# Sustainable Traffic Solutions

RE: Responses to Comments on the Traffic Impact Study for the Haven School

## *Traffic Impact Study*

PCD File # AL2322

Scale	NTS	Date	June 25, 2024	Drawn by	JLH	Job #	Haven School	Figure	22
-------	-----	------	---------------	----------	-----	-------	--------------	--------	----

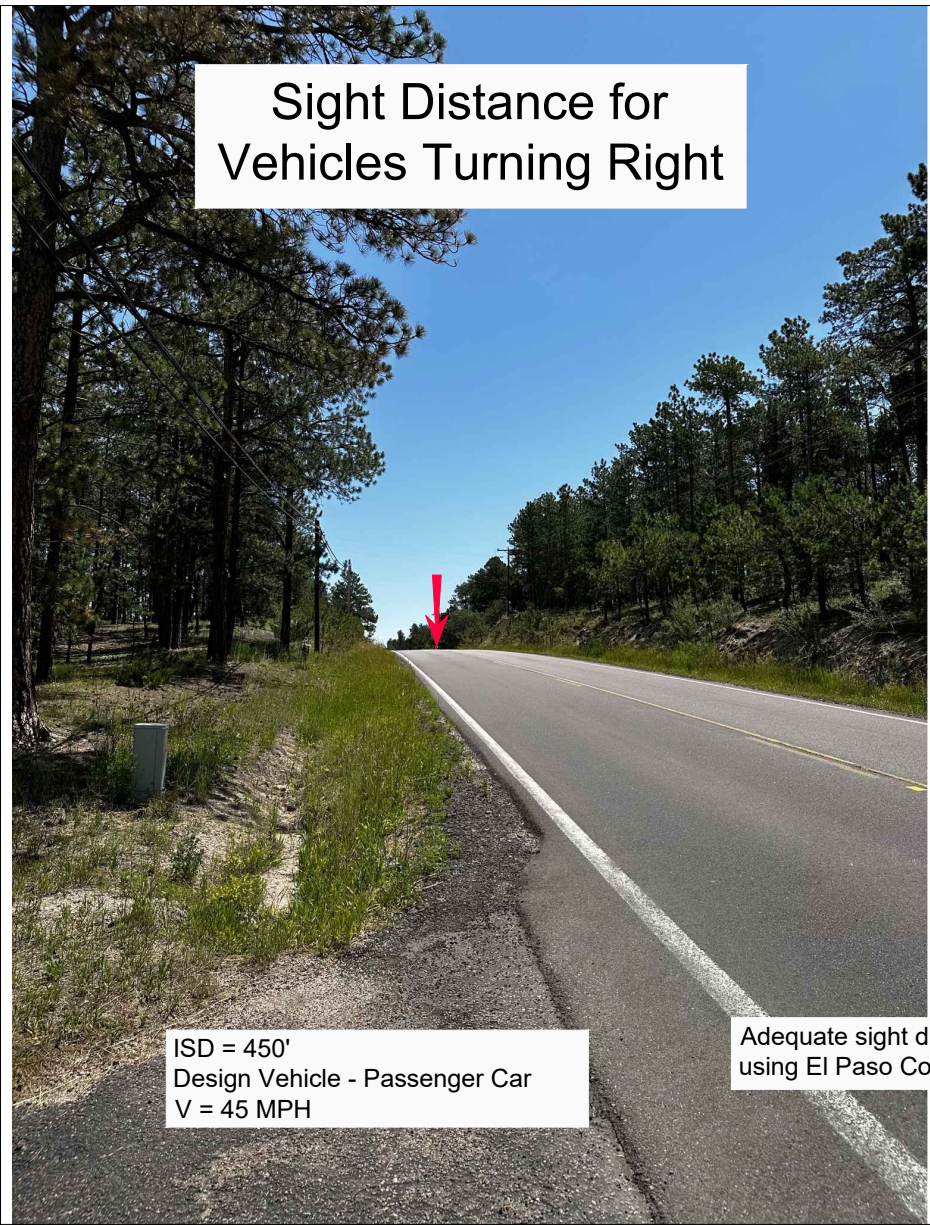
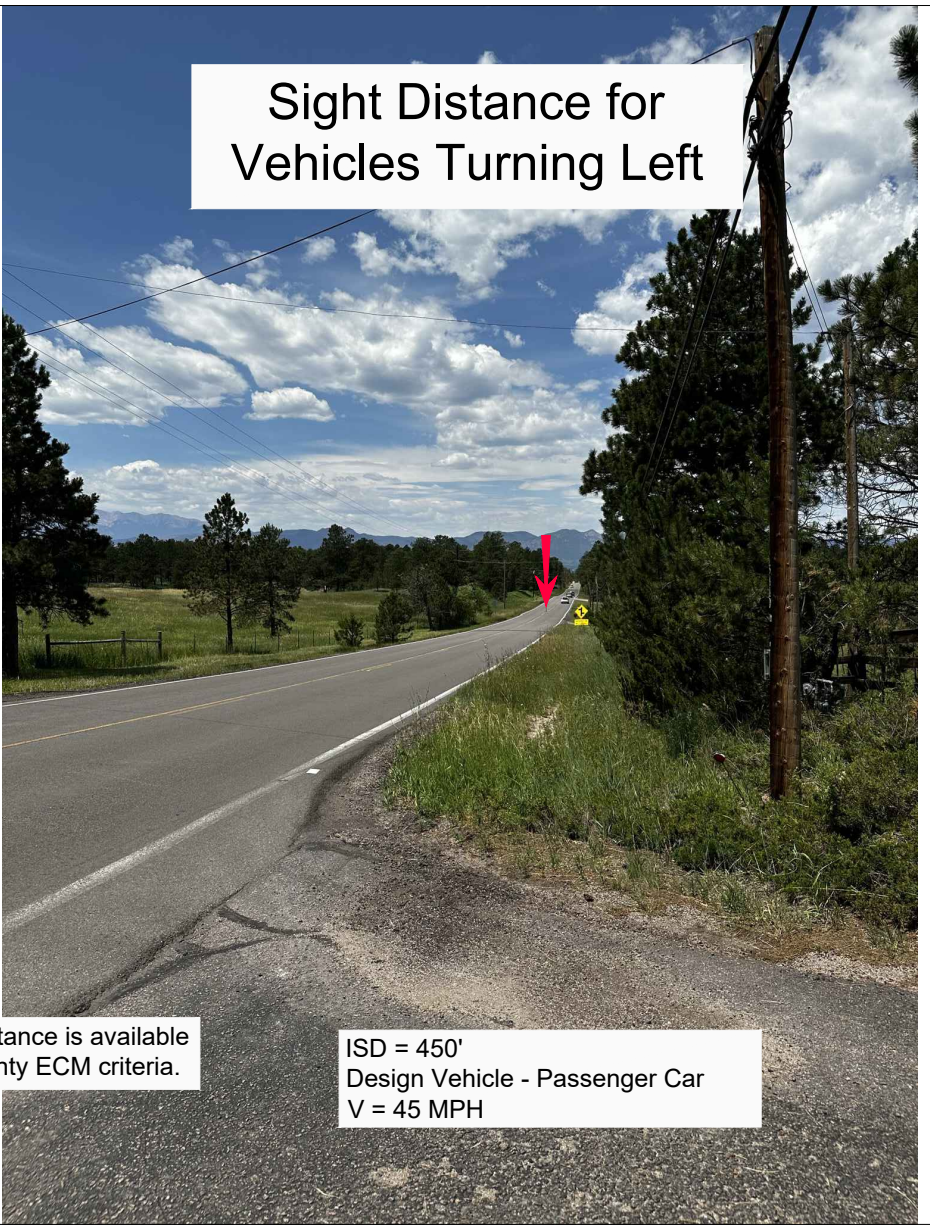
**Comment 13** Please state in the text what the ECM sight distance criteria are and state whether they are met.

**Comment 14** Design Vehicle Selection per ECM Table 2-36 shall be single unit truck for a school bus type route. For a school entity a school bus can be expected. Update sight distance and submit a deviation if not met.

**Response** The change was made.

**Response** The entering sight distance was only verified for the passenger vehicle because buses and trucks are not expected to use the access based on information provided by the Haven School. Considering the vertical geometry, there isn't enough sight distance to accommodate a school bus.
